SWIM PROJECT PROFILE		File No. : 194
Regist. No. : Agency No. : BSWM-113	Name: LABOON SWIP	
Region: 8	Province: SOUTHERN LEYTE	Municipality: MAASIN
Present Status: 1. Pre-F/S( )    ② F/S(1983)    ③ D/D(1983)		
Purpose: Major : Irrigation Incidental : IF, FC, WM		
Project Feature:

SWIM PROJECT PROFILE		File No. : 195
Regist. No. : Agency No. : BSWM-114	Name: POLANQUI SWIP	
Region: 8	Province: EASTERN SAMAR	Municipality: TAFT
Present Status: 1. Pre-F/S( ) ② F/S(1983) ③ D/D(1983)		
Purposo: Major : Irrigation Incidental : IF, FC, WM		
Project Feature:

SWIM PROJECT PROFILE		File No. : 213
Regist.No. : Agency No. : BSWM-133	Name : KITAO-TAO SWIP	
Region : 10	Province : BUKIDNON	Municipality : KITAO-TAO
Present Status : 1. Pre-F/S( )    ② F/S(1983)    ③ D/D(1983)		
Purpose: Major : Irrigation Incidental : IF, FC, WM		
Project Feature:

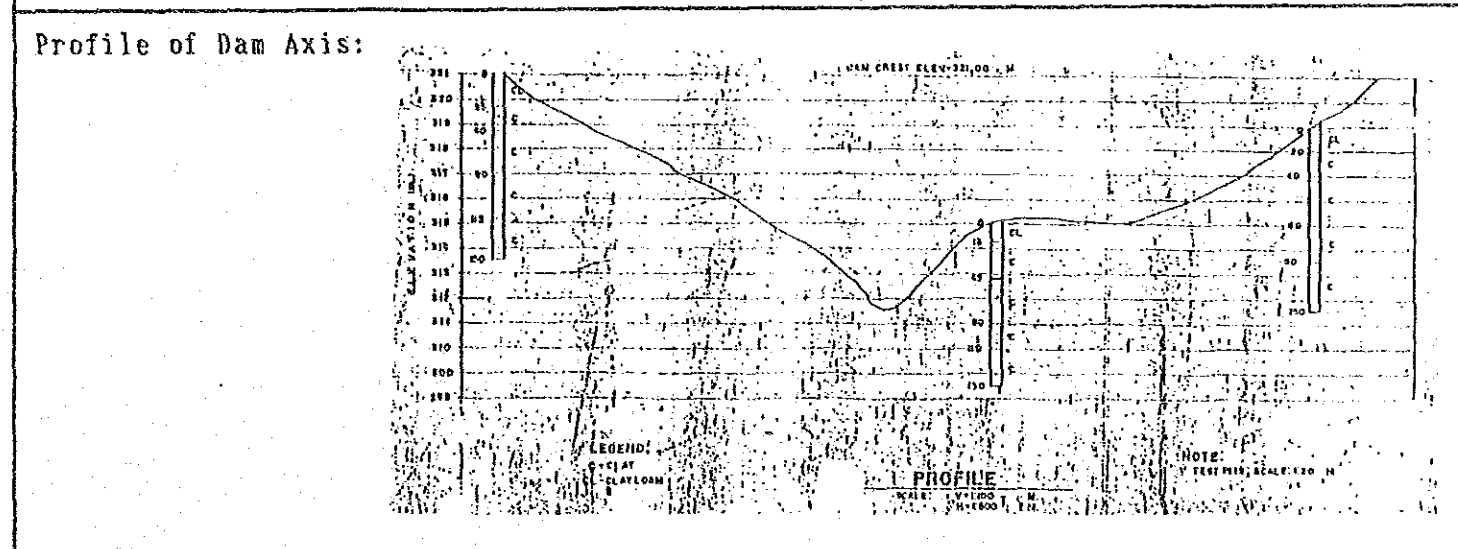
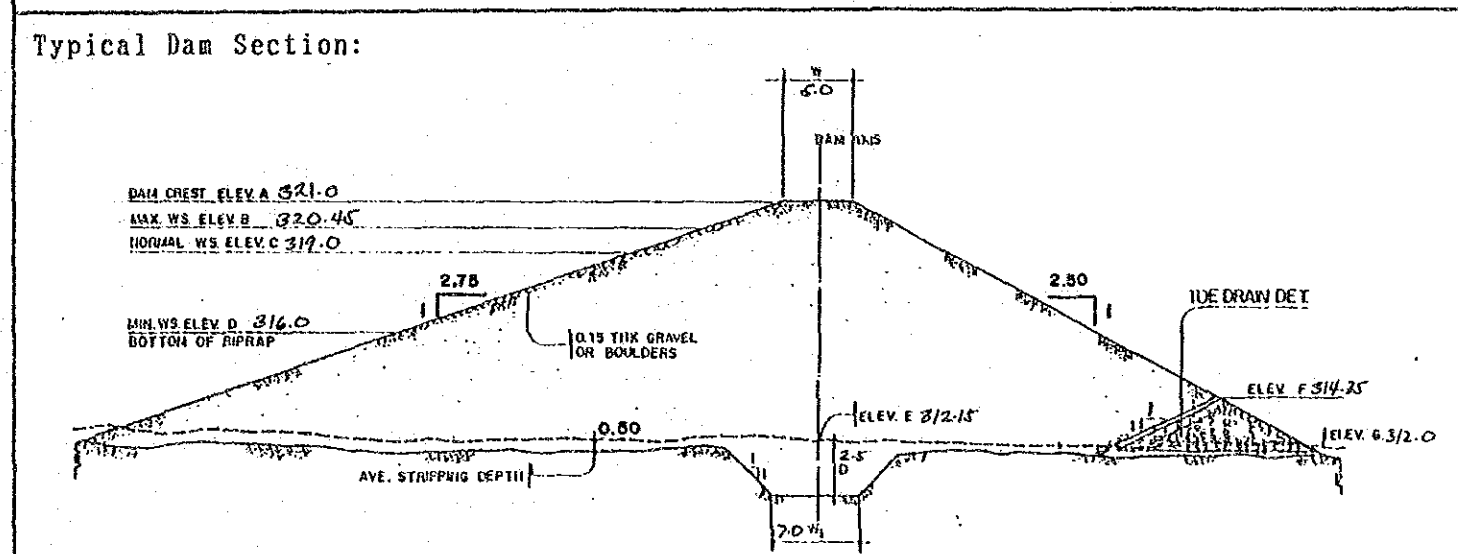
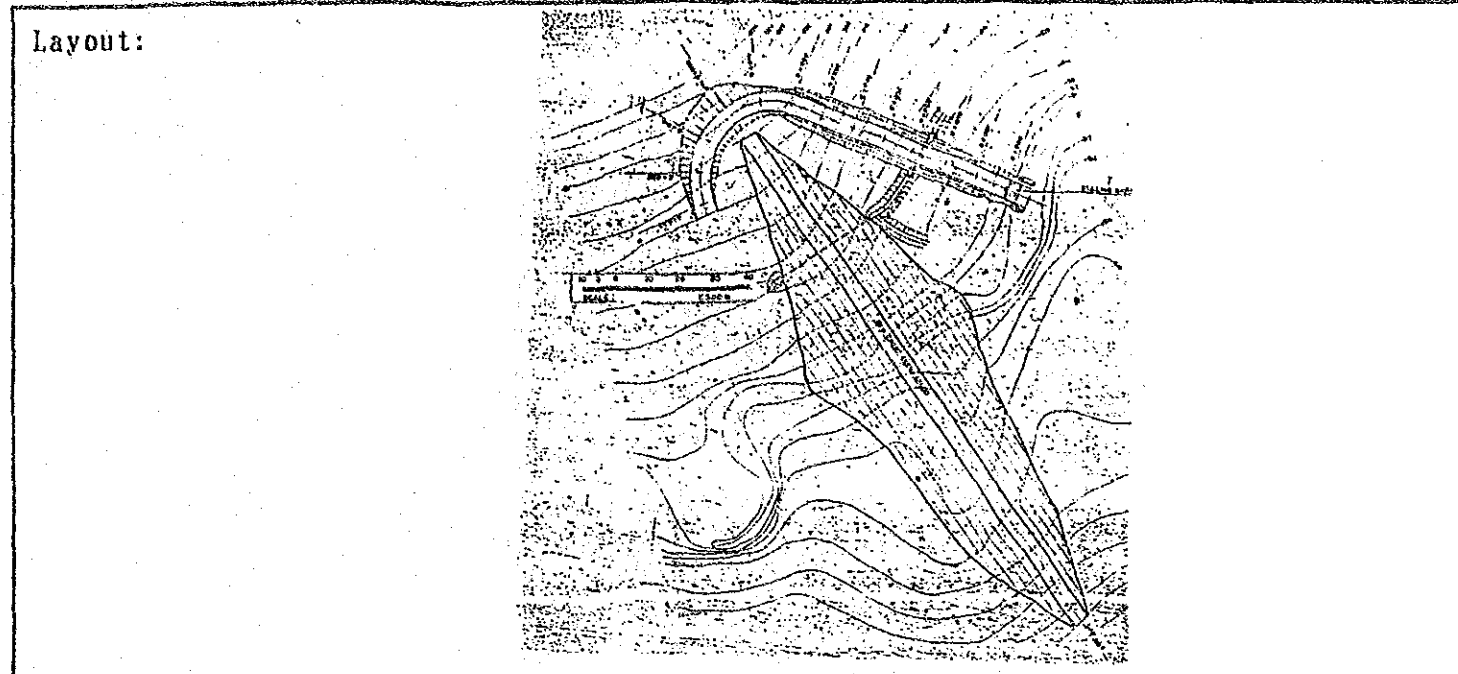
2. Planning Environmental conservation plan is not formulated.		
3. Design Seepage through volcanic tuff shall be studied. Stability of upstream slope of the dam shall be checked. Weir shall be provided in the spillway.

Note: Silt with more than 1.5 m depth is piled up on the volcanic tuff. Permeability test in silt and tuff layer is required.

SWIM PROJECT PROFILE		File No. : 214
Regist. No. : Agency No. : BSWM-134	Name : SAN RAFAL SWIP	
Region : 11	Province : DAVAO ORIENTAL	Municipality : CATEEL
Present Status : 1. Pre-F/S( )    ② F/S(1983)    ③ D/D(1983)		
Purpose: Major : Irrigation Incidental : IF, FC, WM		
Project Feature:

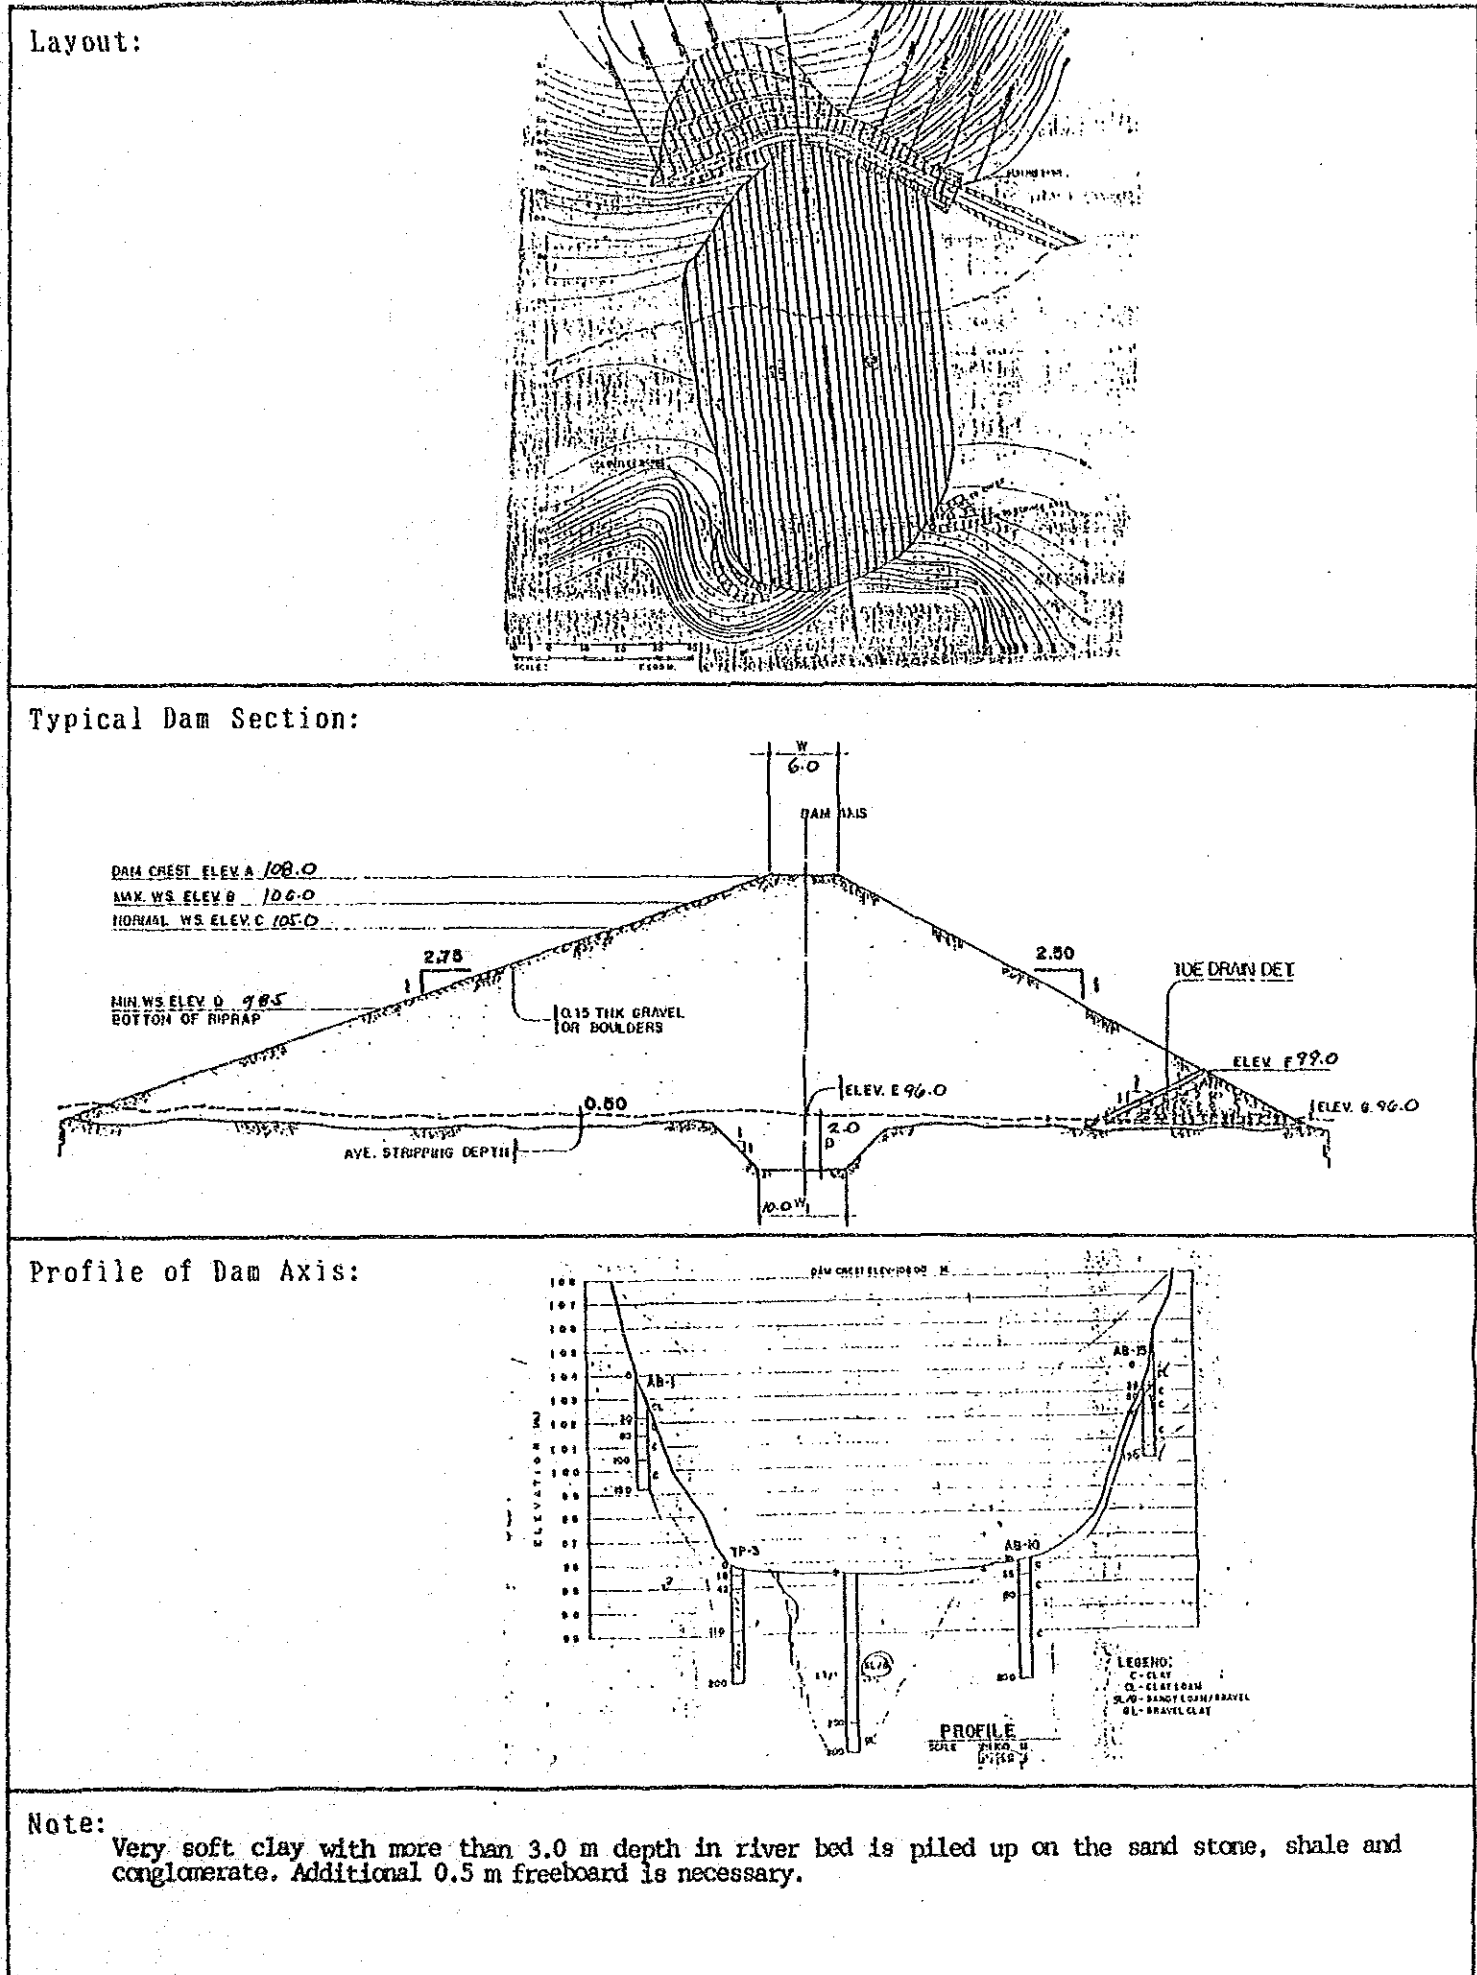
2. Planning Environmental conservation plan is not formulated.		
3. Design Stability analysis is necessary not only for upstream slope of the dam but also for sliding in the soft foundation. Center line of the spillway shall be shifted to left side. Weir shall be provided in the spillway. Center line of conduit is recommended to be straight.

SWIM PROJECT PROFILE		File No. : 215
Regist. No. : Agency No. : BSWM-135	Name: BUKAY-PAIT SWIP	
Region: 11	Province: SOUTH COTABATO	Municipality: TANTANGAN
Present Status: 1. Pre-F/S( ) ② F/S(1983) ③ D/D(1983)		
Purpose: Major : Irrigation Incidental : IF, FC, WM		
Project Feature:

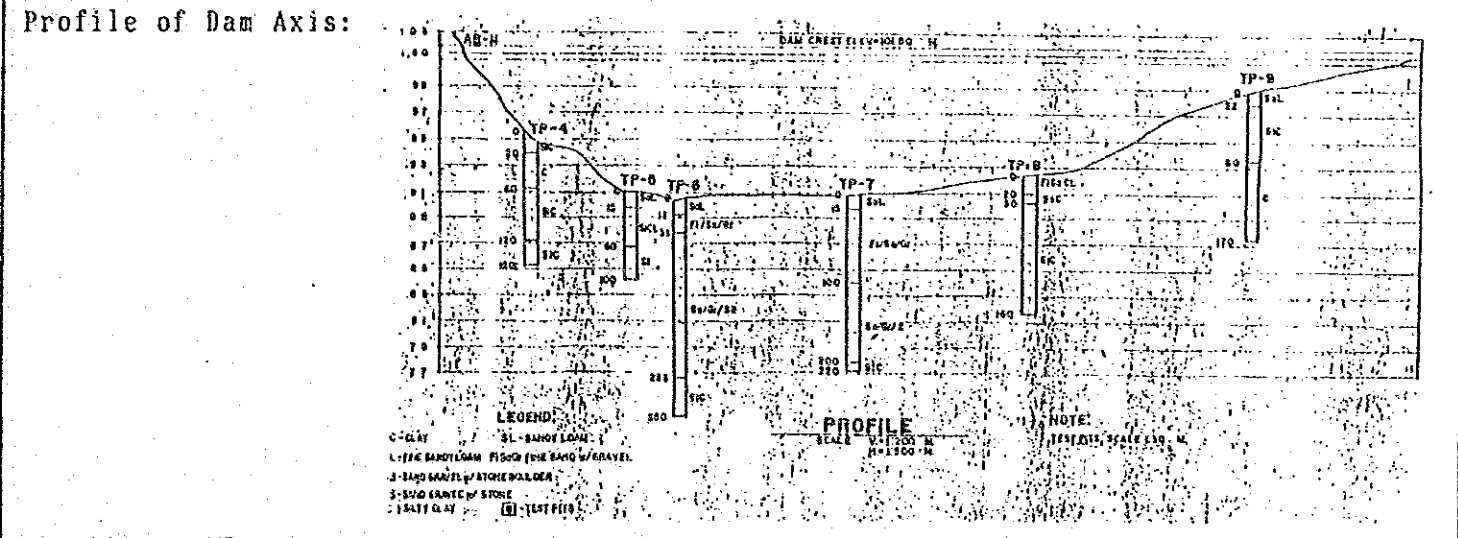
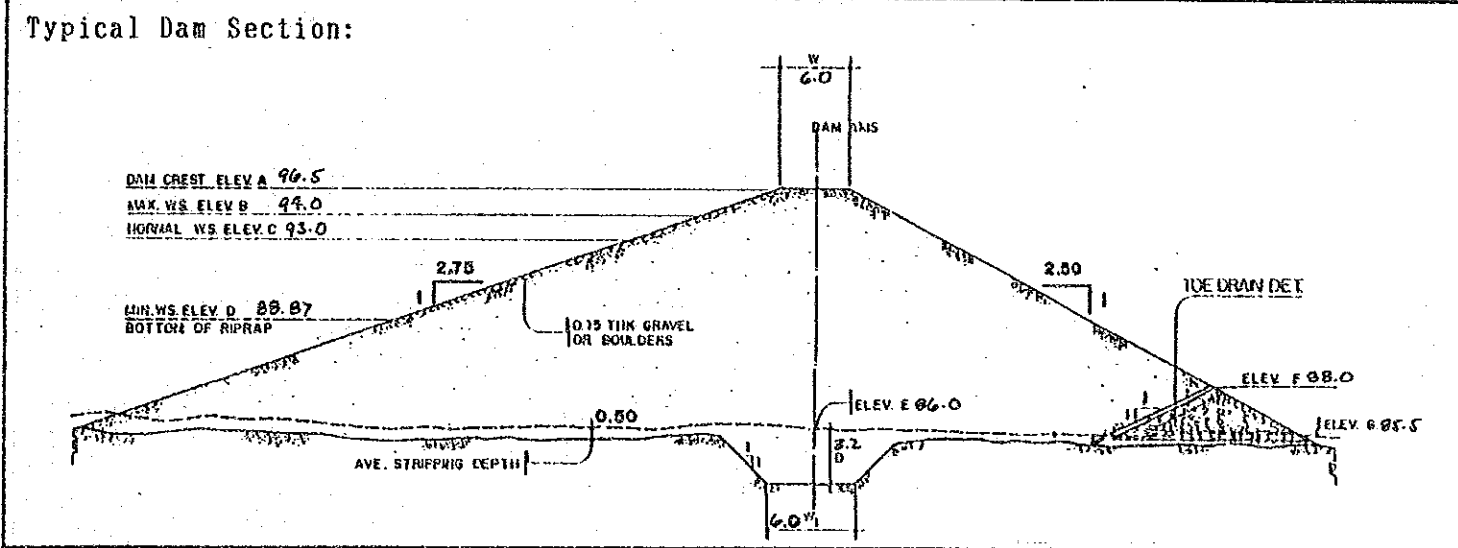
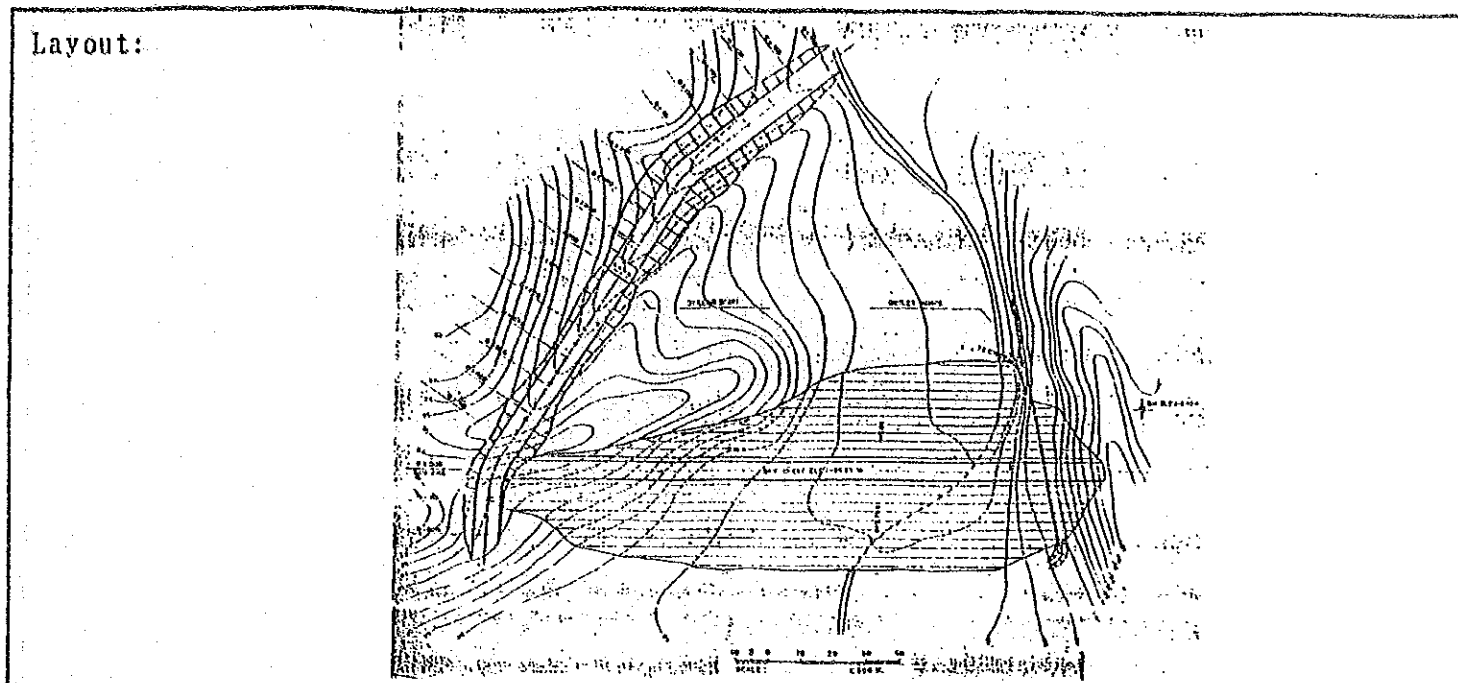
2. Planning Environmental conservation plan is not formulated.		
3. Design Stability of upstream slope of the dam shall be checked. Center line of the spillway shall be shifted to left side. Weir shall be provided in the spillway.

SWIM PROJECT PROFILE		File No. : 216
Regist.No. : Agency No. : BSWM-136	Name : LIBUDON SWIP	
Region : 11	Province : DAVAO ORIENTAL	Municipality : MATI
Present Status : 1. Pre-F/S( )    ② F/S(1983)    ③ D/D(1983)		
Purpose: Major : Irrigation Incidental : IF, FC, WM		
Project Feature:

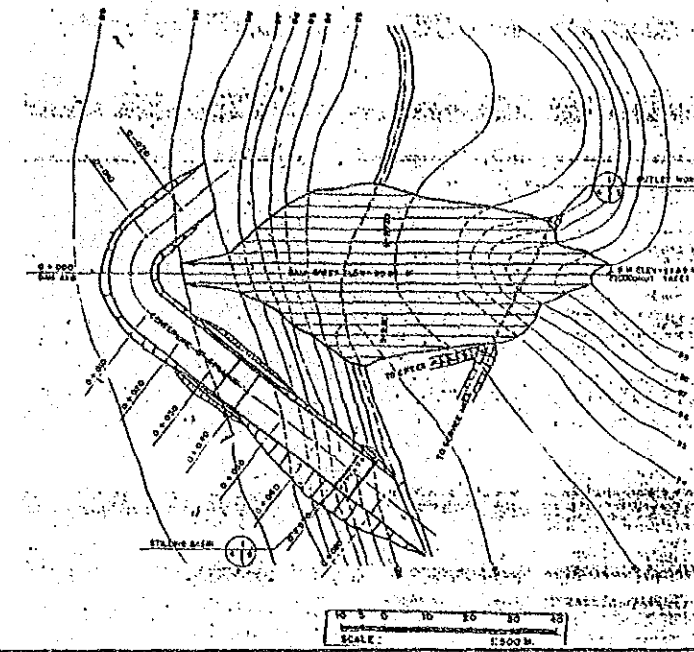
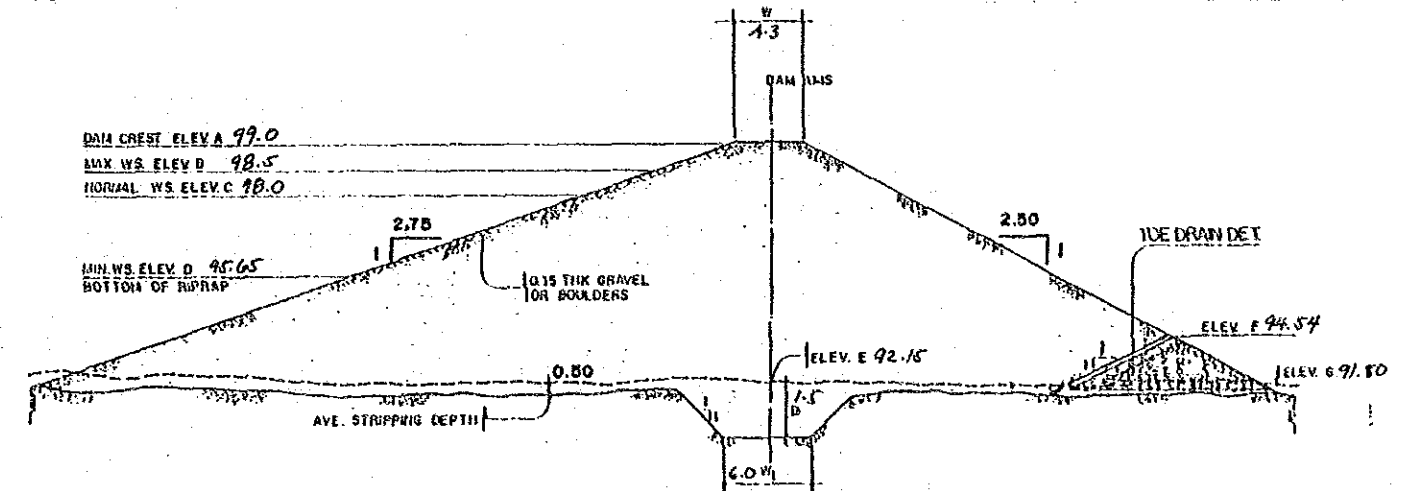
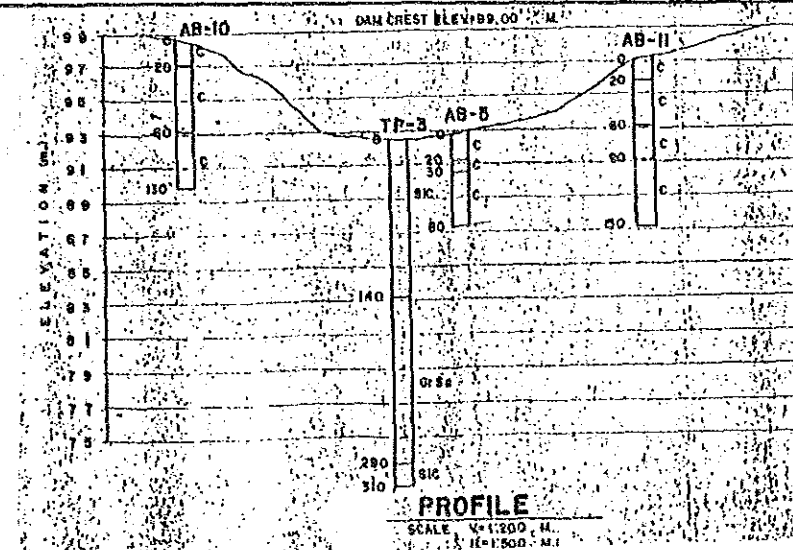
2. Planning Environmental conservation plan is not formulated.		
3. Design Depth of core trench shall be modified during construction. Stability of upstream slope of the dam shall be checked. Weir shall bUp stream slope of dam shall be checked by stability
